## Access Compliance Report Public Rights-of-Way (Curb Ramps)

Intersection ID: 42388 Main Street: JAVITZ\_RD Cross Street: POZZI\_RD Location: SW

ADA ID: 810322C7E0A8 Ramp Type: BlendTrans1 Initial Pass/Fail: Fail Overall Compliance: No Severity Score: 25

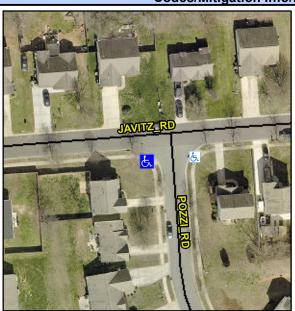
PROW/ADA:
Not Found, R304.5.3

Field Measurements/Component Compliance					
Compliance Description		Data	Compliance Description		Data
N/A	Ramp Length (in)	45.5	Yes	BlendTrans Slope (%)	3.3
Yes	Ramp Width (in)	84.0	No	BlendTrans XSlope (%)	9.3
N/A	Flare Type LT	N/A	N/A	Flare Type RT	N/A
N/A	Flare Slope LT (%)	N/A	N/A	Flare Slope RT (%)	N/A
N/A	Flare Traversable LT?	N/A	N/A	Flare Traversable RT?	N/A
N/A	Landing Length (in)	N/A	N/A	DWS Provided?	N/A
N/A	Landing Width (in)	N/A	N/A	DWS Contrast?	N/A
N/A	Landing Slope (%)	N/A	N/A	DWS Length (in)	N/A
N/A	Landing X Slope (%)	N/A	N/A	DWS Full Width?	N/A
N/A	Landing Curb? (Y/N)	N/A	N/A	DWS Offset (in)	N/A
N/A	Shared Landing?	N/A			
N/A	Gutter Ponding?	N/A	N/A	Gutter Slope (%)	N/A
N/A	Gutter Lip Ht (in)	N/A	N/A	Gutter X Slope (%)	N/A
N/A	Painted X Walk1?	No	N/A	Painted X Walk2?	N/A
	X Walk 1 Direction	To SE		X Walk 2 Direction	N/A
	X Walk 1 Width (in)	N/A		X Walk 2 Width (in)	N/A
	X Walk 1 Slope (%)	1.4		X Walk 2 Slope (%)	N/A

Remove & Replace Curb Ramp With
Two New Directional Ramps or
Equivalent.
